INSTRUCTION TO SERVICE

ITS: 6415

SECTION:	231 Cooling System
WRITTEN BY:	Mike Pearson
SUBJECT:	Replace CAC tube support bracket

Figure 1: CAC Tube Support Tube Bracket and U-clamp

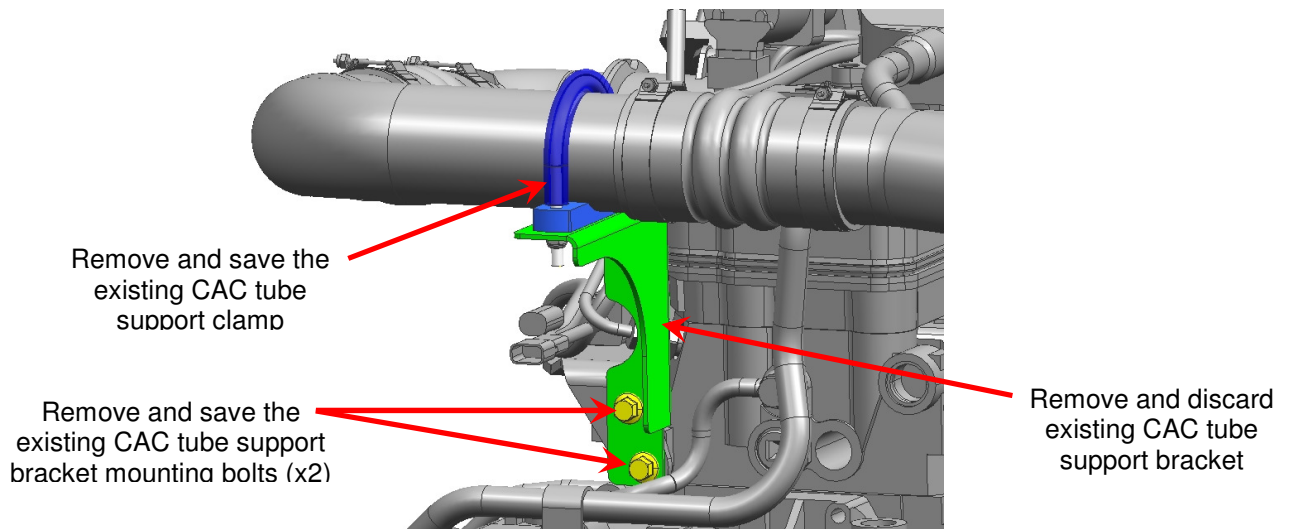
1. Turn the main battery disconnect switch to the "OFF" position.
2. Open the interior and exterior engine access doors.
3. Working from the interior engine access door locate, remove and save the existing CAC tube support clamp, see Figure 1.
4. Remove and save the existing CAC tube support bracket mounting bolts (x2), discard existing CAC tube support bracket. See Figure 1.

Figure 2: CAC Tube Support Tube Bracket Installation

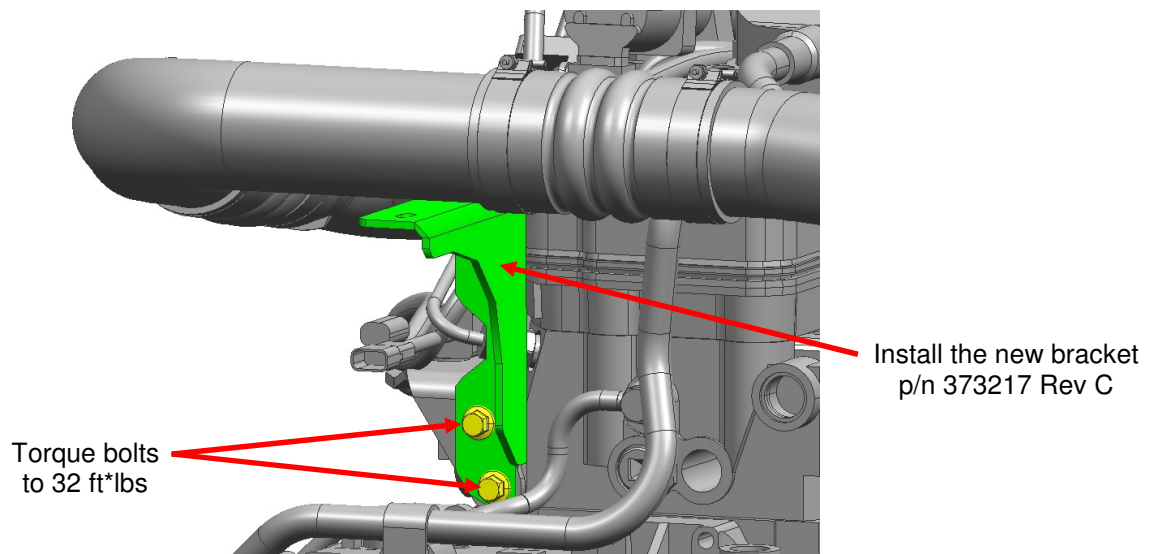
5. Using the existing bolts (x2) from Step 4 install the new bracket p/n 373217 Rev C in the same mounting holes and orientation as the original bracket, torque bolts to 32 ft*lbs. See Figure 2.

Figure 3: CAC Tube Support Clamp Installation

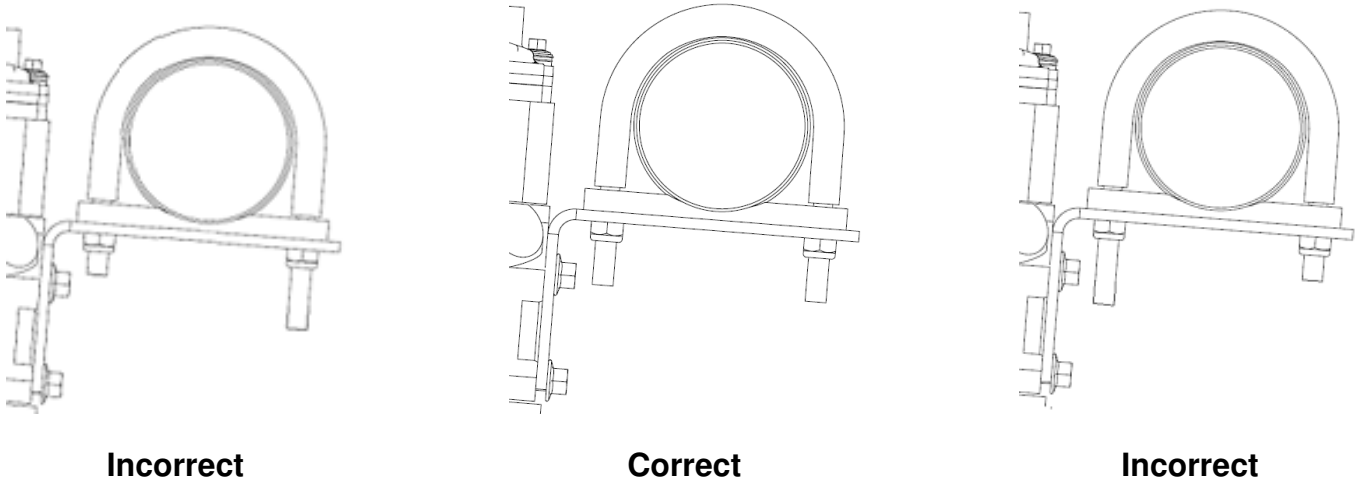
6. Install existing U-bolt clamp from Step 4 as shown in Figure 3. When tightening the existing U-bolt clamp nuts the nuts are to be tightened alternately so the same amount of threads show on both clamp studs when installation is complete. See Figure 3 for correct clamp nut alignment (stud length has been exaggerated and clamp bracket appearance might vary).
